**REVIEW COMMENTS ON ESF ALCOVE GROUND
SUPPORT ANALYSIS AND ESF GROUND
SUPPORT—STRUCTURAL STEEL ANALYSIS**

**Nuclear Regulatory Commission
Contract NRC-02-93-005**

**Center for Nuclear Waste Regulatory Analyses
San Antonio, Texas**

January 1997

Figure 1. Variation of Q values along North Ramp and associated support categories (from Williams, 1996).

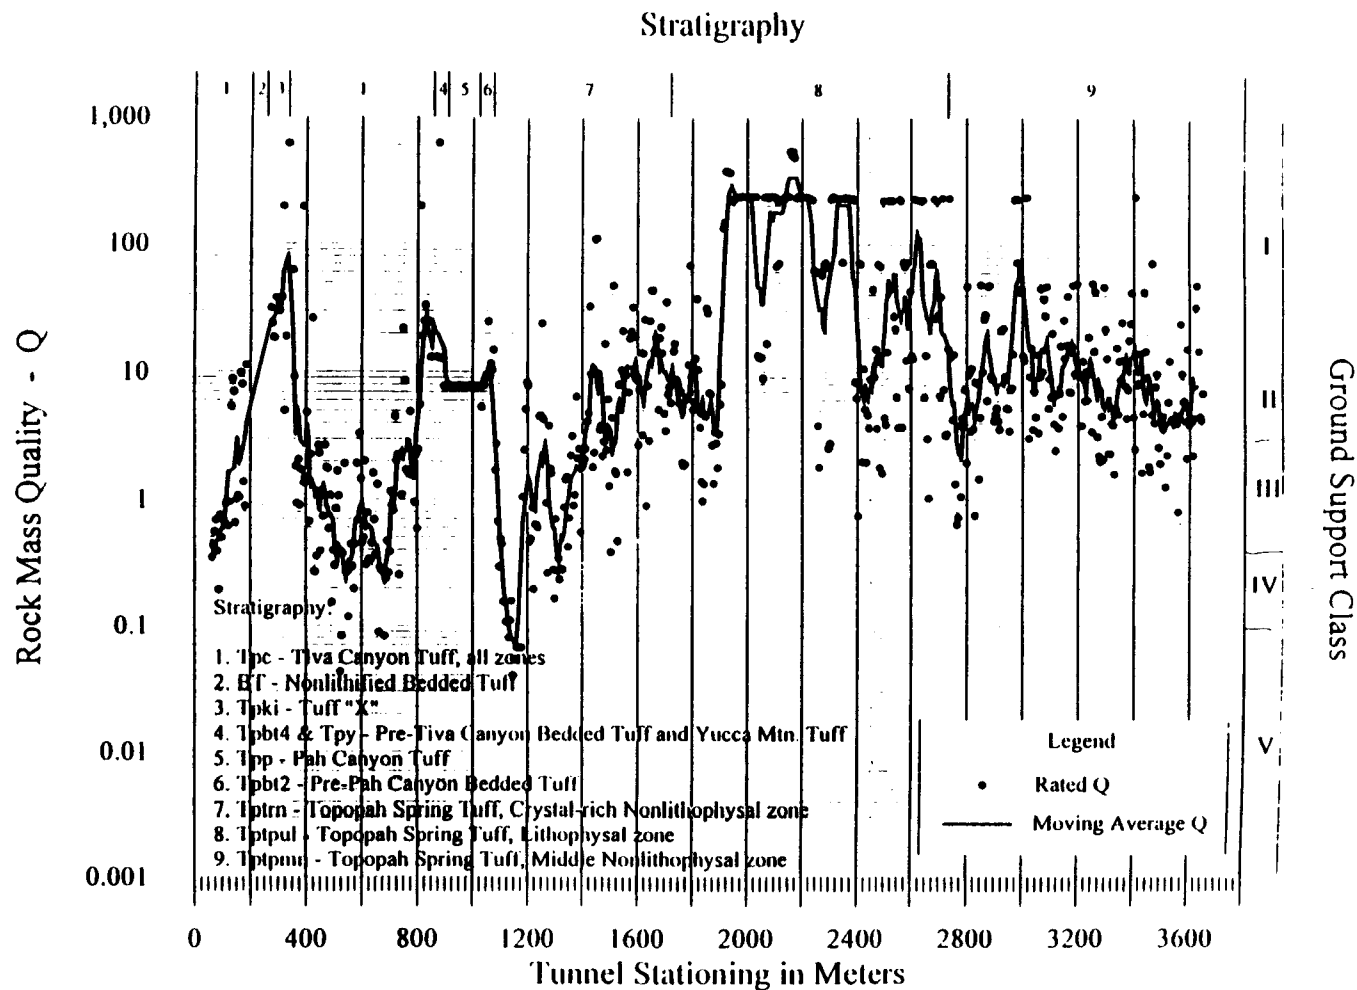
Figure 1 from Williams (1996) illustrates the relationship along with the measured Q values and moving average. In this figure, different TM units are shown for identification purposes only along the ESF tunnel. This methodology is acceptable and causes less confusion than the previous methodology which created different meanings of rock mass quality in different TM units.
